SUBMITTAL IDENTIFICATION SHEET

WEBSTER UNIVERSITY ISB	
PROJECT NAME	
8274 BIG BEND BLVD	
ADDRESS	
NUMBER	
WEBSTER UNIVERSITY	
OWNER	
CANNON DESIGN	
ARCHITECT / ENGINEER	
Devin Gates	
SUBMITTED BY	
098453-001 REV 1	
CONTRACTOR / CM SUBMITTAL NO.	CANNON DESIGN SUBMITTAL NO.
	098453
DRAWING / DETAIL REFERENCE	SPECIFICATION SECTION / PARAGRAPH
MANUFACTURER / SUPPLIER	ITEM / PRODUCT ID
REQUIRED DATE	PRIORITY
	CRITICAL

Project Name: 15051-Webster University Interdisciplinary Science Building Project No.: 15051

Subject: Mullion Mate Color

9 PLAN DETAIL AT EXTERIOR CURTAINWALL

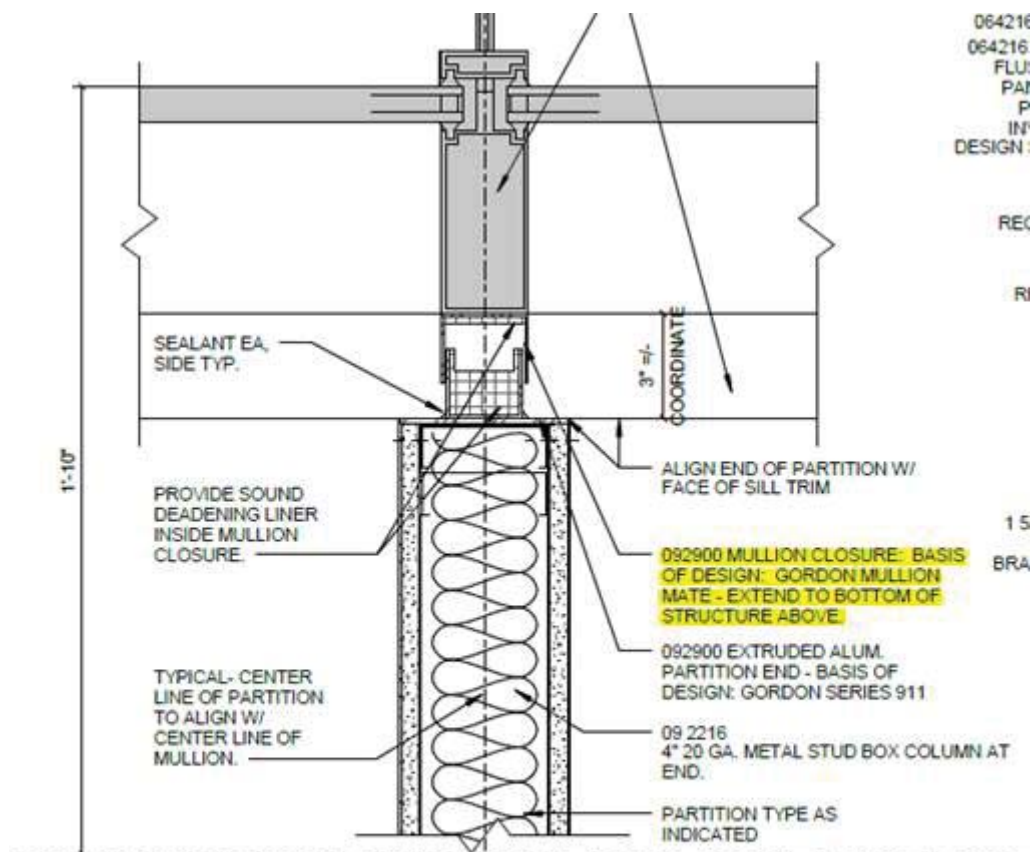
I am requesting additional clarification on this. You've selected 4 of the powder coated colors marked standard finishes. This does not resolve the issue on our end as there is still a significant premium so I am looking for additional information showing this was called out in the drawings/specs so that it could have been bid accordingly.

You mentioned in the OAC meeting the spec says “standard colors” for the mullion mates but the spec simply says “Use products indicated on the drawings or architect approved equivalents”.

Below is a screenshot of what is called out on the drawings.

Please let me know if I am missing something in the specs or drawings and I will certainly ensure the additional costs should have been covered on our end.

Mullion-mate is specified under specification section 098453, see below-

- 2.4 ALUMINUM FINISHES
- A. Color Anodic Finish: AAMA 611, AA-M12C22A42/A44, Class I, 0.018 mm or thicker.
1. Color: As selected by Architect from full range of industry colors and color densities.

On second thought, we want the mullion-mate to match mullion color so that it matches with the curtainwall sill trim below (Mullion-mate size should be same as the curtainwall sill trim below).
